## ADDENDUM NO. 1

**NOTICE is hereby given to prospective Bidders** of the following information, clarifications, and modifications to the Bidding Documents. The Bidding Documents remain unchanged except for modifications specifically indicated under Modifications. Bidders must acknowledge receipt of this Addendum in the Bid Form and comply with the requirements for submission of Bids as set forth in the Bidding Documents.

**Prepared and Issued by Woodard & Curran (Engineer) on behalf of Owner:**

**CAPE ELIZABETH WWTF UPGRADES**

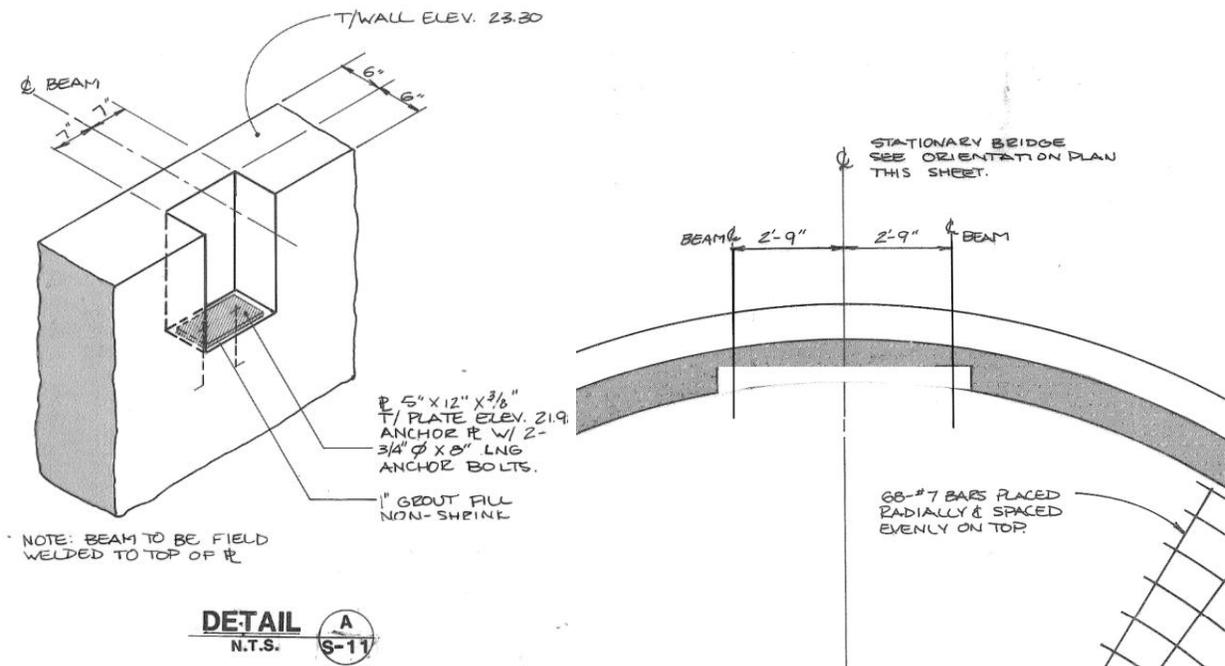
- c. *Question: It appears that you are converting domed half bridge pier supported plow type clarifiers to full bridge supported spiral blade. Most of the drawings are of the existing half bridge. There are some elevations, but no dimensions. Things like how the bridge will land is one part that’s lacking detail; one drawing shows the half bridge set into the tank walls with the dome on top of the wall, but the full bridge drawing shows the bridge on top of the wall and no mention of the dome. Any additional information on these details would be welcomed.*

Answer: Existing full bridge is supported from notches in exterior walls. Proposed mechanism shall be supported in the same way. See attached photos and images from record drawings showing pocket for bridge beams.

**ATTACHMENT C - CLARIFIER DOME  
SUBMITTAL**

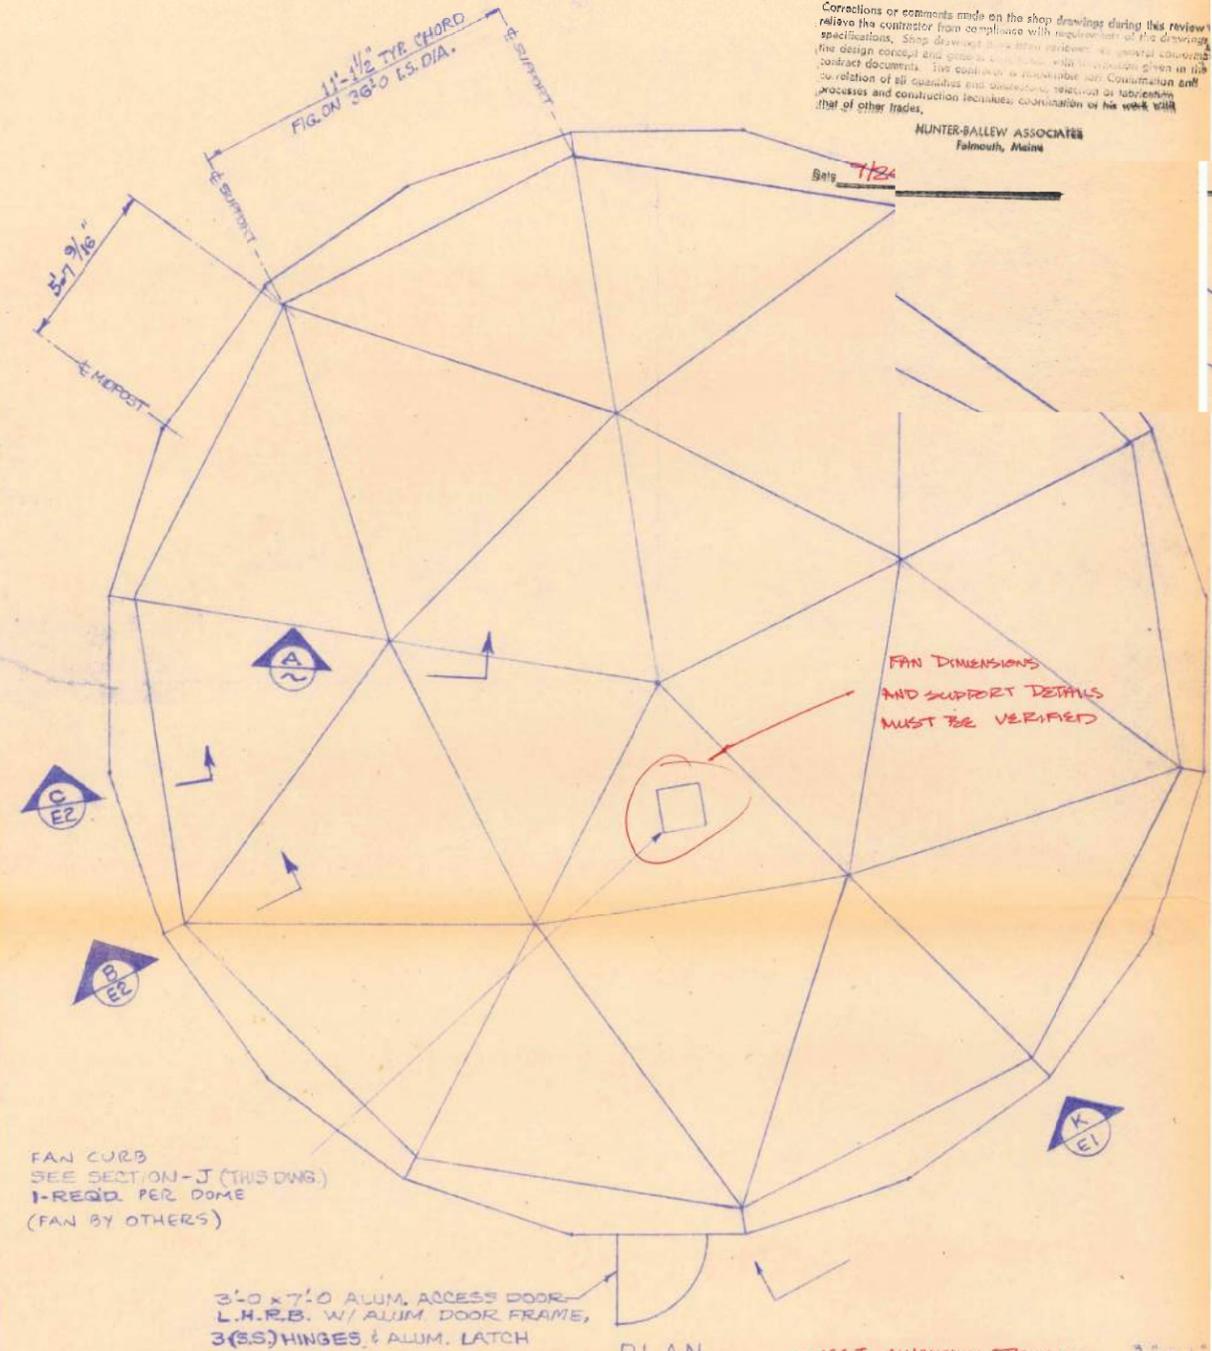
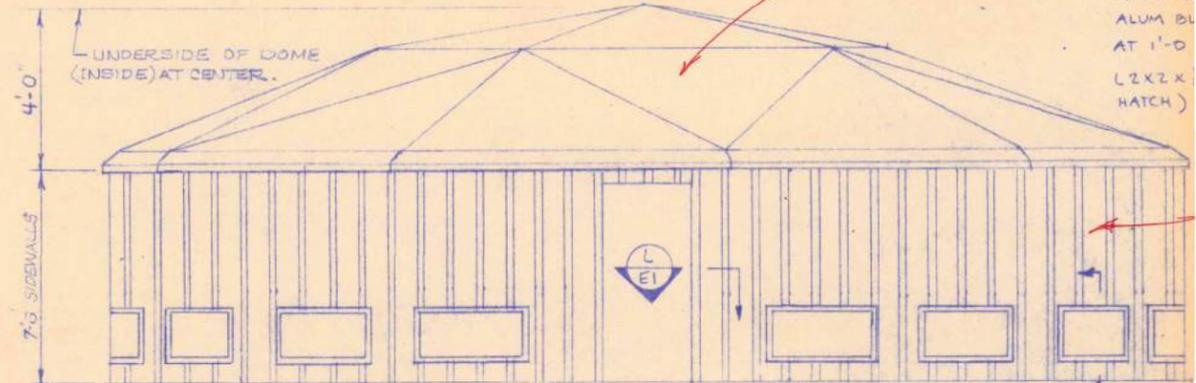
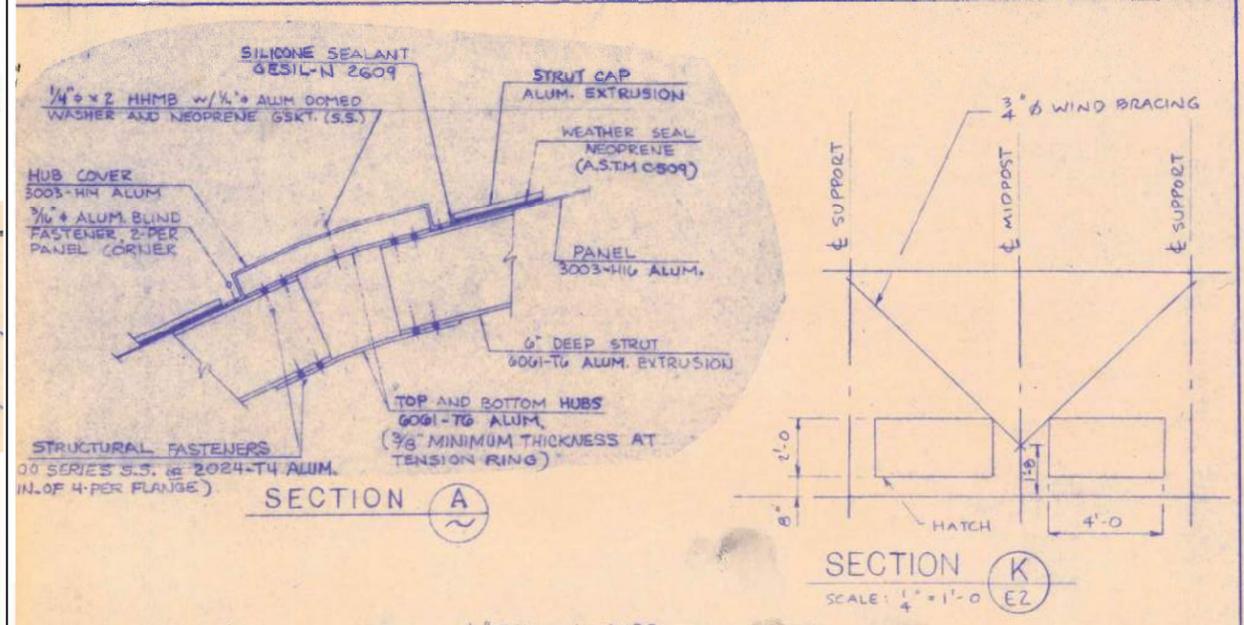
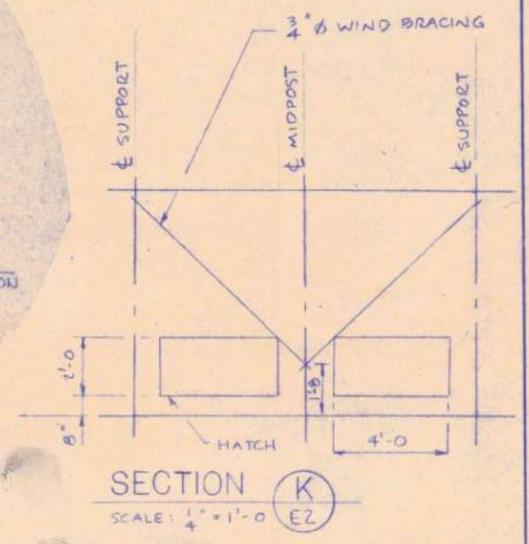
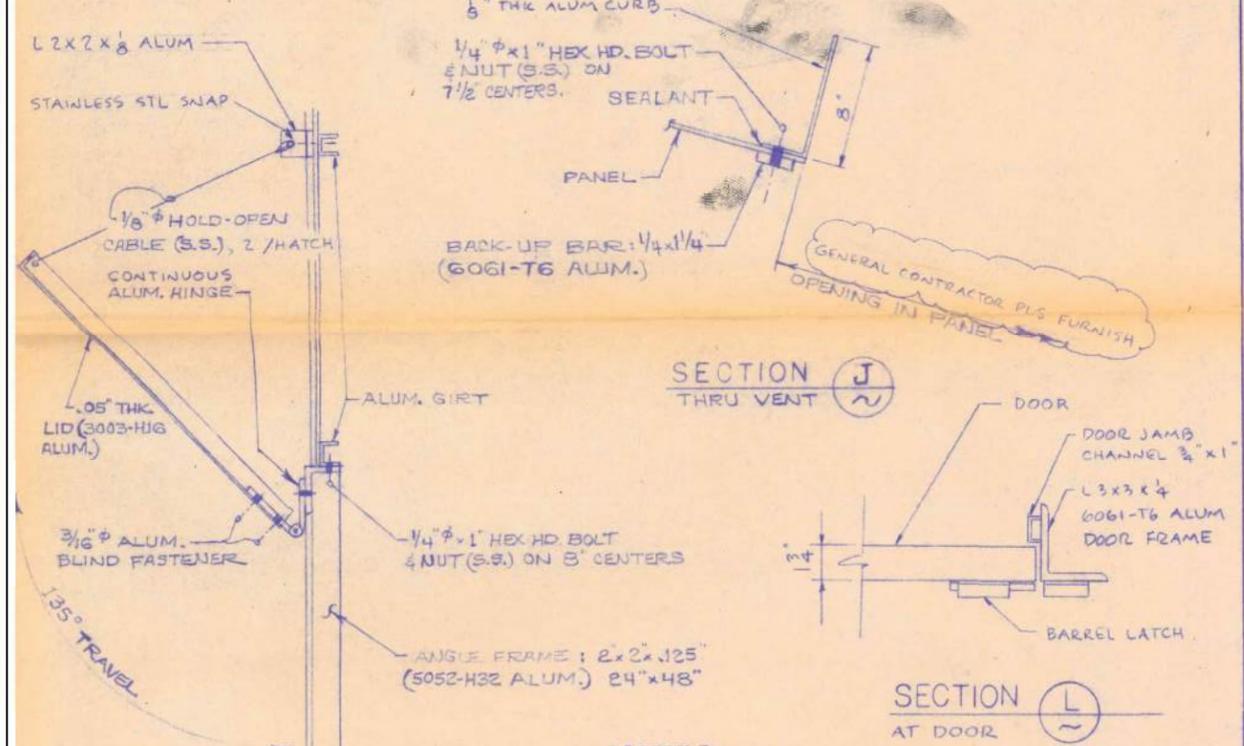
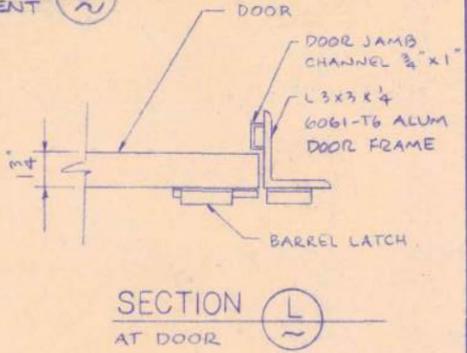
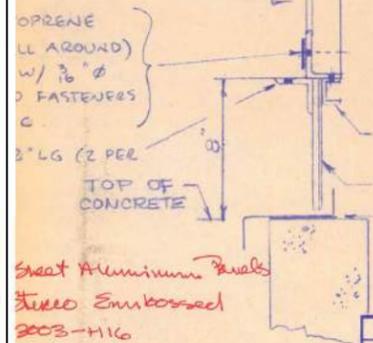
- e. *Question: With the dome, what sort of space do we have to fit equipment into the tank? The General Notes do mention the option for the contractor to remove the dome, or at least portions, for the demo and install work. Any additional information on these details would be welcomed.*

Answer: Refer to original Clarifier Dome shop drawings attached. Reach out to CST with any additional questions. Contact info provided as part of this Addendum.

DRAWING NO:  
**E-03-100**

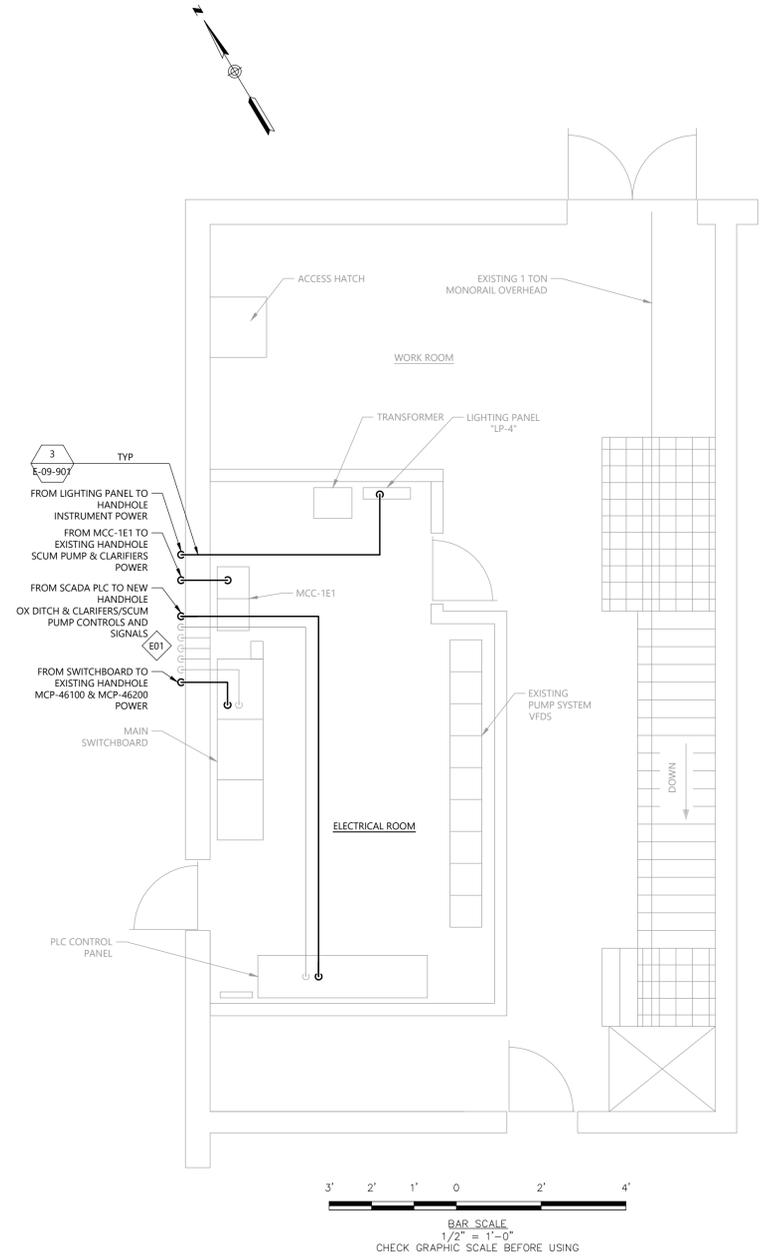
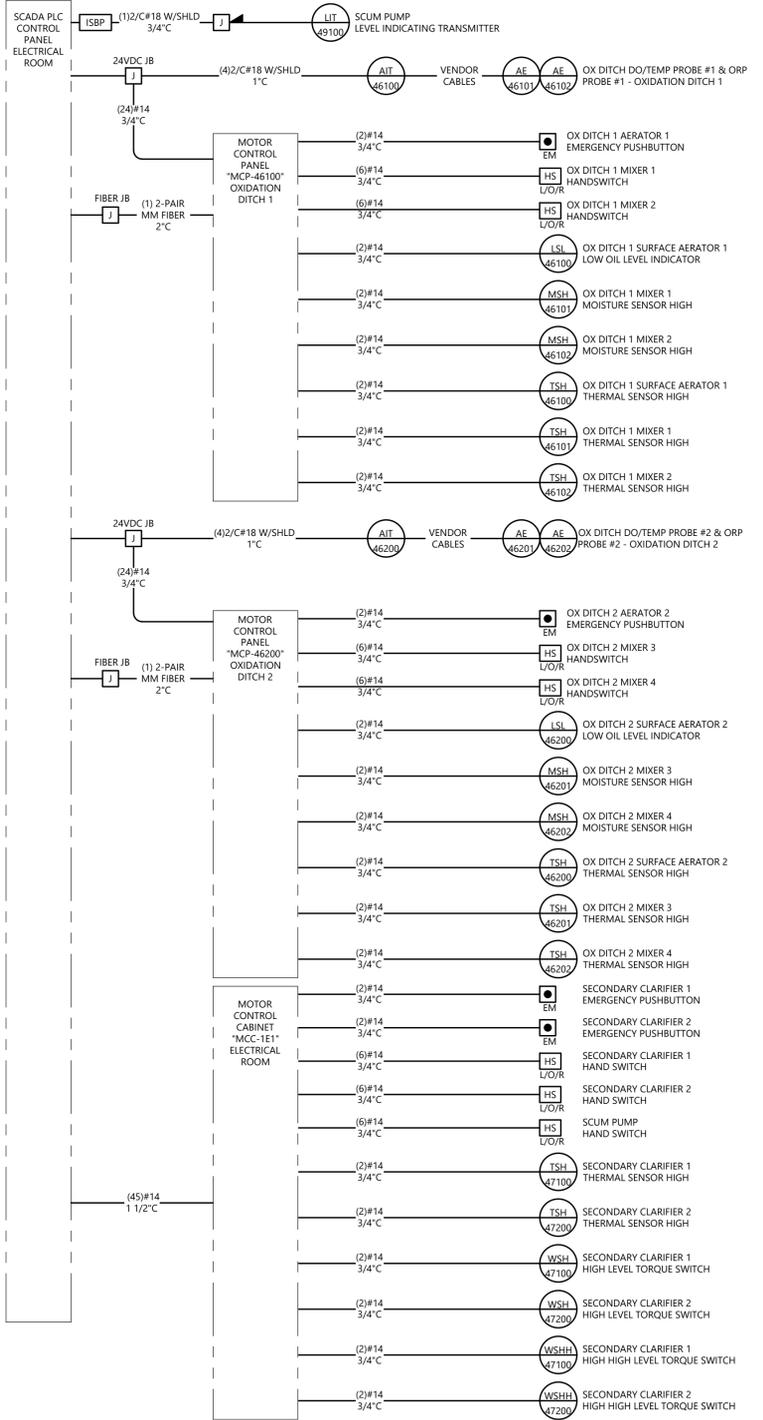
1. *Question: Why is some of the conduit schedule shaded on E-03-100?*  
Answer: The shade in conduit schedule has been removed. Please see reissued sheet E-03-100.
